Our Ref: 21080

RE: SDCC PLANNING REG. REF. SDZ22A/0007

RESPONSE TO FURTHER INFORMATION REQUEST

Figure 1: Extract from Memo, prepared by Atkins Consulting Engineers showing Refuse Vehicle and Pump Vehicle Tracking for the 4no. proposed Homezones.

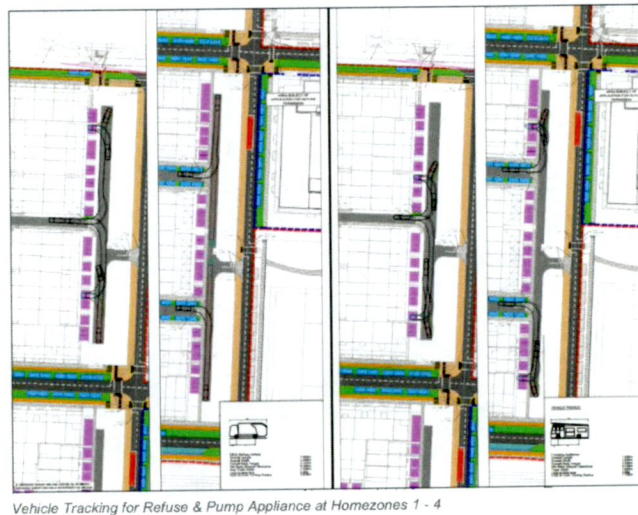
(a) A revised layout of not less than 1:200 showing a turning area at the end of Homezones adjacent to the linear park, or an autotrack showing vehicle manoeuvres to allow for safe turning.

(a) In conjunction with other design team disciplines Atkins Consulting Engineers examined several turning head options in order to facilitate turning for each of the four homezones (refer to enclosed Drawing No.5150924/HTR/SK/0001, prepared by Atkins Consulting Engineers). Two issues were identified with all options for this, as outlined in the enclosed FI Response Memo:

1. *"Significant reduction in pedestrian and cycling connectivity. According to the Design manual for Urban Roads and Streets, designers must place pedestrians at the top of the user hierarchy. The introduction of turning heads for the homezones would limit connectivity while introducing longer walking distances for pedestrians. This shown in the two figures below (pedestrian and cycling connectivity with and without the turning heads).*
2. *The introduction of turning heads onto the homezones would result in encroachment onto linear park and associated landscaping. This would, once again, reduce the beneficial impact of the linear park itself by limiting connectivity to stream road."*

In order to address the problems identified above, it is proposed to retain the original layout. As shown in Figure 1 below, refuse and pump appliance are able to turn via reverse movements. Additionally, it is anticipated that refuse collection will occur during off-peak times and can therefore use the parking bays which will be free to facilitate turning. We additionally refer the Planning Authority to the enclosed Drawing No. 5150924/HTR/10/SK-0003, prepared by Atkins Consulting Engineers).

Figure 2: Extract from Memo, prepared by Atkins Consulting Engineers showing revised Adamstown Way junction.

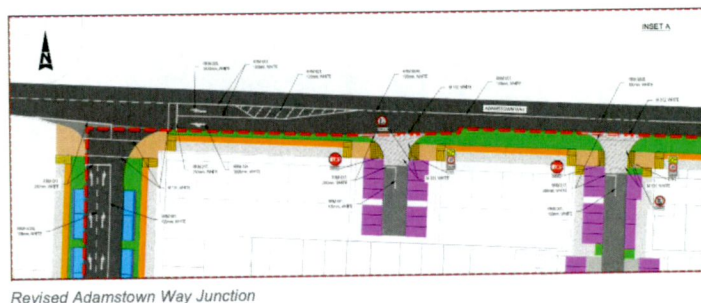
(b) A revised layout of not less than 1:200 showing the road layout for the vehicle access at the northern end with Adamstown Way.

- (b) The Adamstown Way junction has been revised in order to allow for vehicle access, as shown in Figure 2 below. This has involved adjusting the proposed road markings on Adamstown Way. We additionally refer the Planning Authority to the enclosed Drawing No. 5150924/HTR/SK/002, prepared by Atkins Consulting Engineers.

Figure 3: Extract from Drawing Number 5150924/HTR/10/SK/0004 'Existing and New Temporary P&R', prepared by Atkins Consulting Engineers

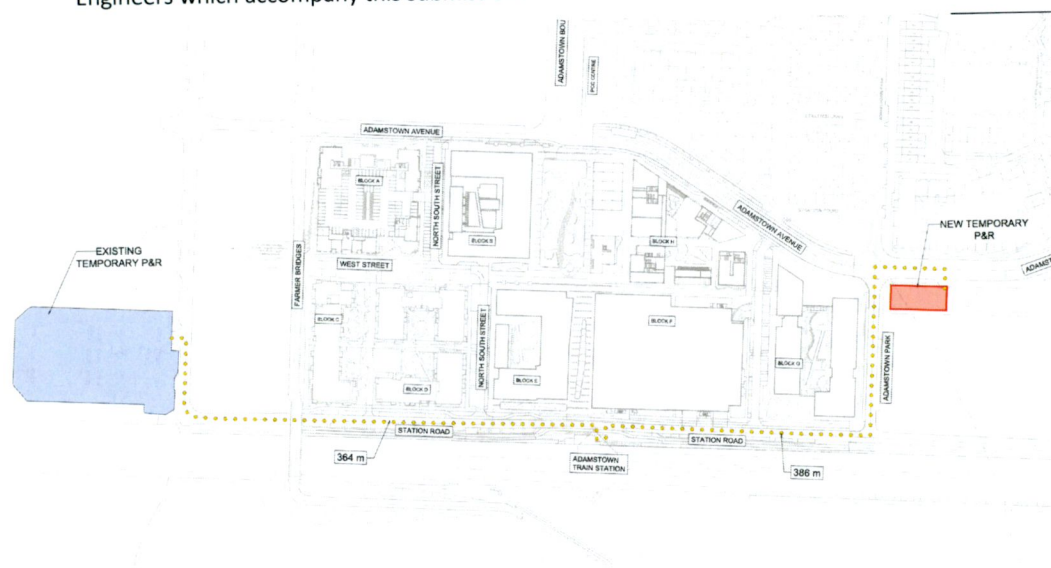
The NTA has requested that the temporary park and ride on the subject site be retained until such a time as a permanent park and ride is available. The applicant is requested to provide a response to the concerns raised by the NTA in this regard.

It is not proposed to retain the existing temporary park and ride facility on site. Anecdotal evidence suggests that this temporary park and ride is in use predominantly by construction workers, with limited cars parked in this facility on a daily basis. It is proposed to use the existing car park located in the Adamstown Square Development Area as a replacement temporary park and ride car park. This contains 26no car parking spaces, including 2 spaces for disabled drivers. We can confirm that the lands on which this car park sits are in the control of the Applicant.

The proposed replacement temporary park and ride facility is located a 4 minute walk from the Adamstown Train Station, approximately 386m away. The existing park and ride facility is located a 4 minute walk from the Adamstown Train Station, approximately 364m away.

Figure 3 below shows the approximate relative proximity of the existing temporary park and ride versus the location of the proposed temporary park and ride facility. We additionally refer the Planning Authority to the enclosed Park and Ride Drawings, prepared by Atkins Consulting Engineers which accompany this submission.

We would invite the Planning Authority to attach a Condition to a grant of Permission in this case which requires the replacement temporary park and ride to be operational, including obtaining any permissions necessary to enable this to occur, prior to works commencing on Phase 3 of the proposed housing element of the current project (ie where the present temporary park and ride is located); thereby ensuring that a temporary park and ride will remain in place to serve Adamstown.
